Rezoning Transportation Analysis

Petition Number: 2019-089

General Location Identifier: 06125112

Date	Description
08-21-2019	First Review (RG)
10-16-2019	Second Review (RG)
08-20-2020	Third Review (KP)

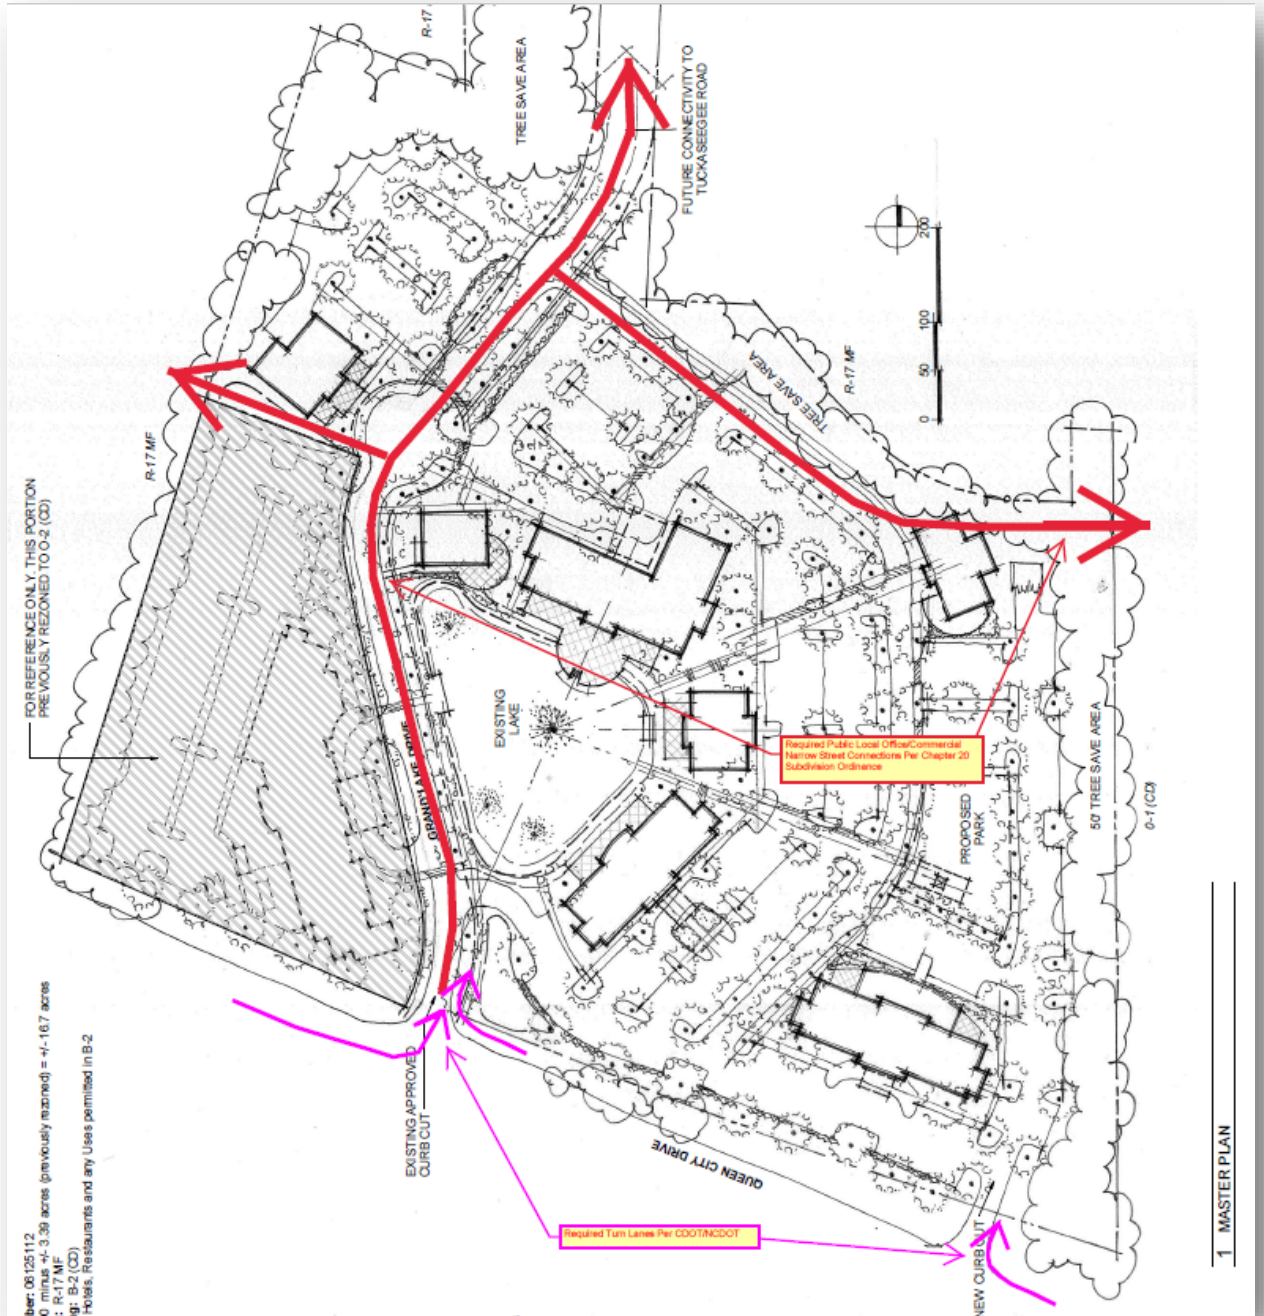
7. The petitioner should revise the site plan and conditional note(s) to commit, implement, and label Grand Lake Dr. within the development as a "pubic" local office/commercial narrow street section (see CLDSM U-04.16). Grand Lake Dr. needs to be constructed to the site's western property line per Chapter 20 of the City Subdivision Ordinance.

9. The petitioner should revise the site plan to add a note specifying the existing Grand Lake Dr. driveway shall have a minimum 100' driveway stem before the first internal driveway.

10. The petitioner should revise the site plan to add a note specifying the proposed driveway located near the site's northern property line, shall be designated as a RI/RO driveway and constructed with a 100' raised median to restrict turning movements at this driveway. Grand Lake Dr. driveway shall have a minimum 50' driveway stem before the first internal driveway.
